RE: Land Use Appeal, Project Number 3018686

I writing to formally appeal the Land Use decision for SDCI project number 3018686 located on 2031 3rd Ave. The proposal is a 36 story, 440' tall office/ residential tower in the Belltown neighborhood.

**RESIDENTIAL TOWER WIDTH DIAGRAM**

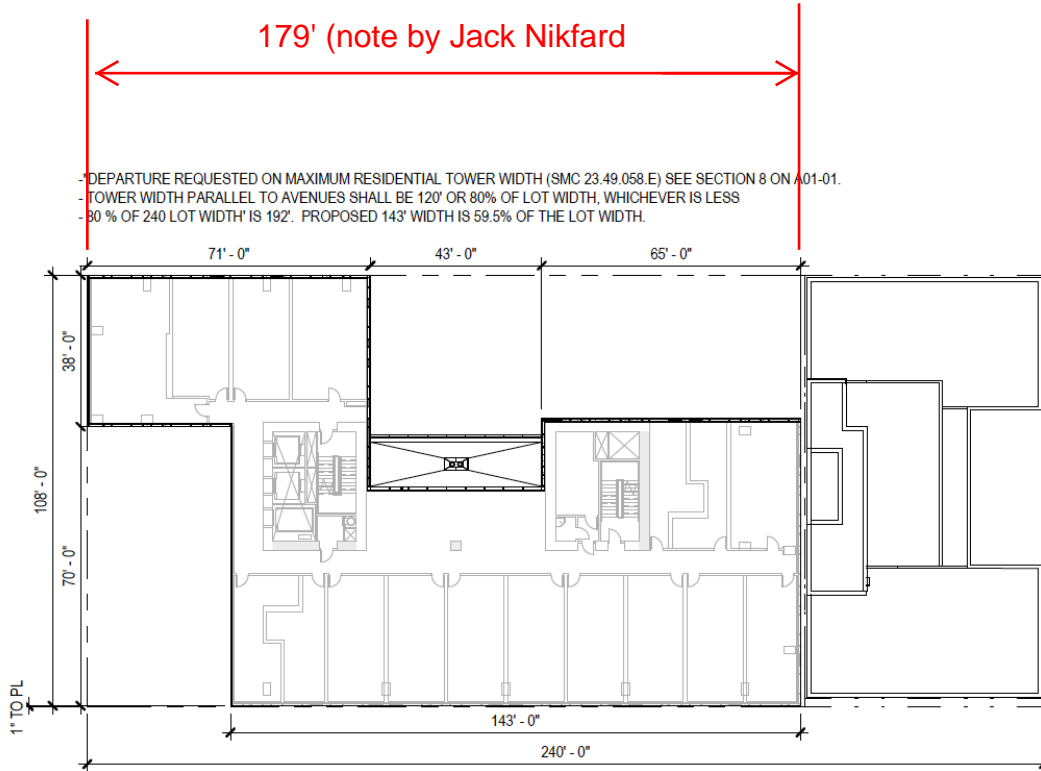
- d. Tower dimension in the "general north/ south axis of the site" totals 179' as described on the fourth Meeting Report and not 144' as presented to the DRB or on the MUP documents. Building elevations from the east and west, the building measures 179'. See Exhibit I

Excerpt from Master Use Permit drawings dated December 22, 2016. General north/ south dimensions total  $71' + 43' + 65' = 179'$  (notes by Jack Nikfard)

② WEST ELEVATION - COLORED MUP  
1/32" = 1'-0"

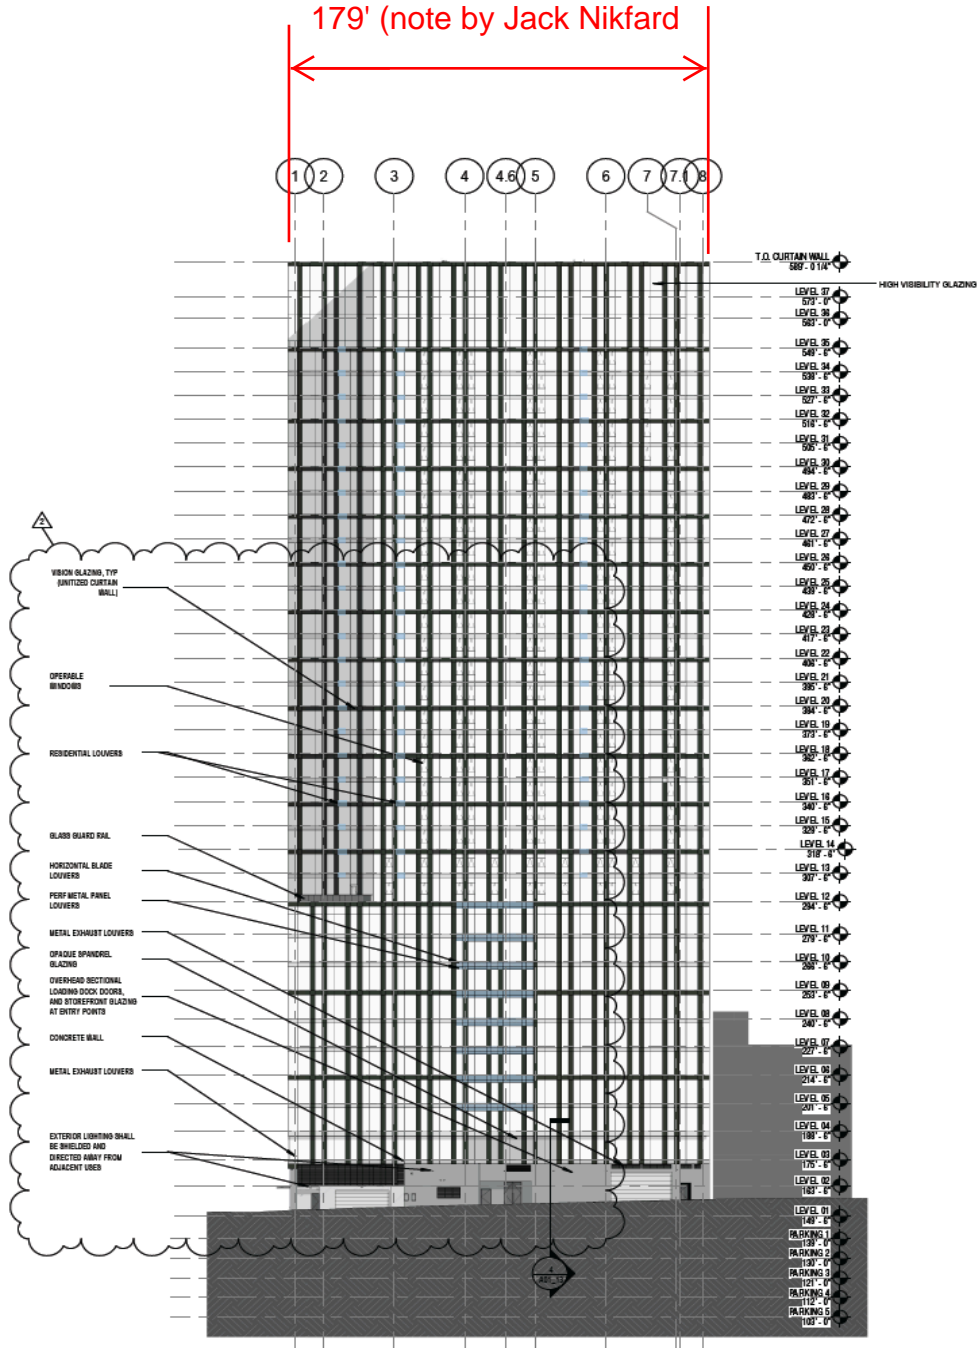
Excerpt from Master Use Permit drawings dated December 22, 2016. General north/ south dimensions total 71' + 43' + 65' = 179' (notes by Jack Nikfard)
